Access Compliance Report Public Rights-of-Way (Curb Ramps)

Intersection ID: 45490 Main Street: COTTON STAND RD Cross Street: GRASSY CROPS RD Location: NE ADA ID: 26024377276D Ramp Type: PerpDiag Initial Pass/Fail: Fail **Overall Compliance: No Severity Score:** 25

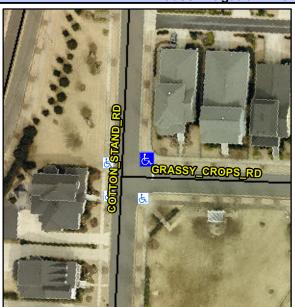
Field Measurements/Component Compliance					
Compliance Description		Data	Comp	liance Description	Data
N/A	Ramp Length (in)	88.0	Yes	Ramp Slope (%)	7.0
Yes	Ramp Width (in)	48.0	No	Ramp XSlope (%)	7.6
N/A	Flare Type LT	N/A	N/A	Flare Type RT	N/A
N/A	Flare Slope LT (%)	N/A	N/A	Flare Slope RT (%)	N/A
N/A	Flare Traversable LT?	N/A	N/A	Flare Traversable RT?	N/A
N/A	Landing Length (in)	N/A	N/A	DWS Provided?	N/A
N/A	Landing Width (in)	N/A	N/A	DWS Contrast?	N/A
N/A	Landing Slope (%)	N/A	N/A	DWS Length (in)	N/A
N/A	Landing X Slope (%)	N/A	N/A	DWS Full Width?	N/A
N/A	Landing Curb? (Y/N)	N/A	N/A	DWS Offset (in)	N/A
N/A	Shared Landing?	N/A			
N/A	Gutter Ponding?	N/A	N/A	Gutter Slope (%)	N/A
N/A	Gutter Lip Ht (in)	N/A	N/A	Gutter X Slope (%)	N/A
N/A	Painted X Walk1?	No	N/A	Painted X Walk2?	No
	X Walk 1 Direction	To W		X Walk 2 Direction	To S
N/A	X Walk 1 Width (in)	N/A	N/A	X Walk 2 Width (in)	N/A
	X Walk 1 Slope (%)	7.2		X Walk 2 Slope (%)	1.4

COTTON STAND RD Street 1 Name Stop Condition-Street 2 Street 2 Name **GRASSY CROPS RD** Stop Condition-Street 1 StopSign Possible Solutions: Remove & Replace Curb Ramp With Two New Directional Ramps or Equivalent. Surveyor Notes: N/A PROW/ADA: Not Found, R304.5.3
